### **IN THE DRAWINGS**

Replacements sheet for Figs. 7, 13, 14, 15 and 16 are submitted herewith. The replacement sheets are submitted to correct minor errors that occurred during the preparation of the formal drawings after the application was filed. The amendments remove the minor errors and make the formal drawings consistent with the informal drawings that were originally filed with the application. The amendments to the drawings are fully supported by the drawings and specification as originally filed, and no new matter has been added.

Fig. 7

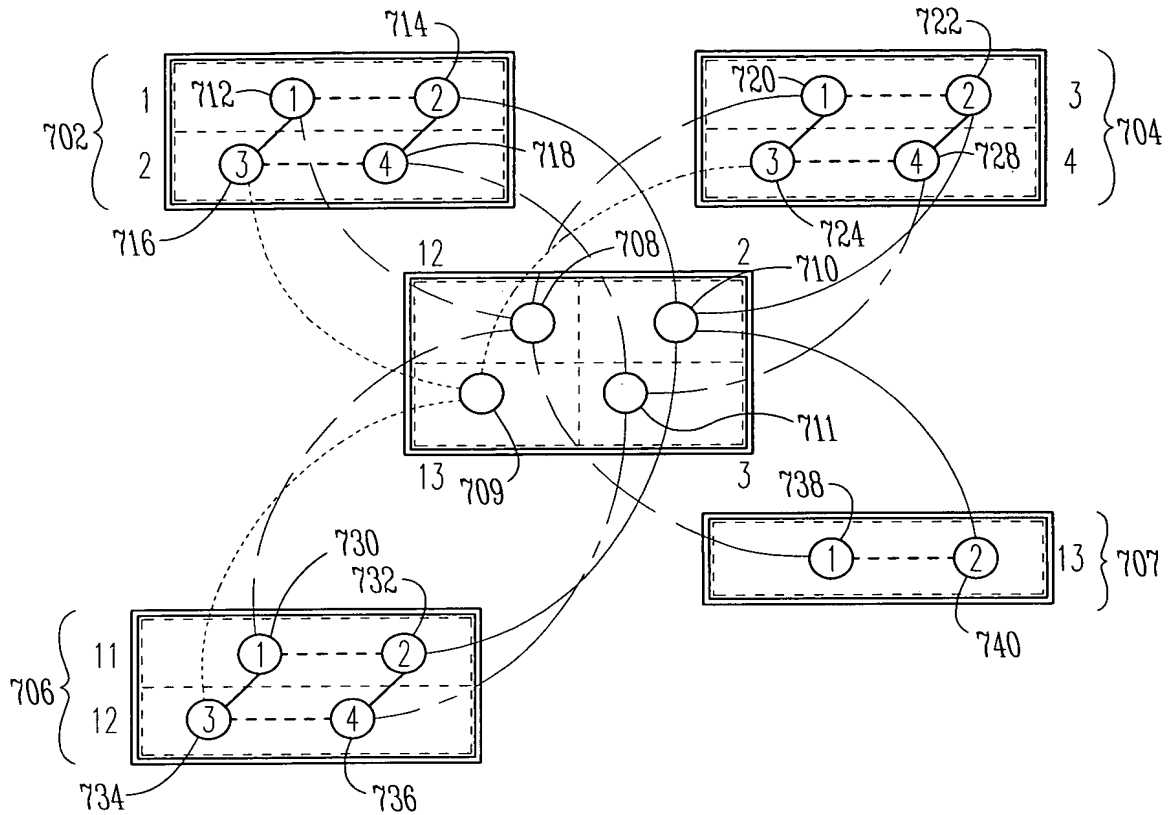
The formal drawing for Figure 7 contained an incorrect reference number. Reference number "604" is changed to "704" in the replacement sheet for Figure 7. The formal drawings for Figures 13, 14, 15, and 16 each incorrectly show the second router of the fourth cluster in the bottom row (the cluster shown with numbers 13, 14) and the second router in the sixth cluster in the bottom row (the cluster shown with numbers 15, 16) both connected to router number two in the middle metarouter of the middle row. The corrected formal drawings remove the connection from the fourth and sixth clusters to router number two in the middle metarouter of the middle row.
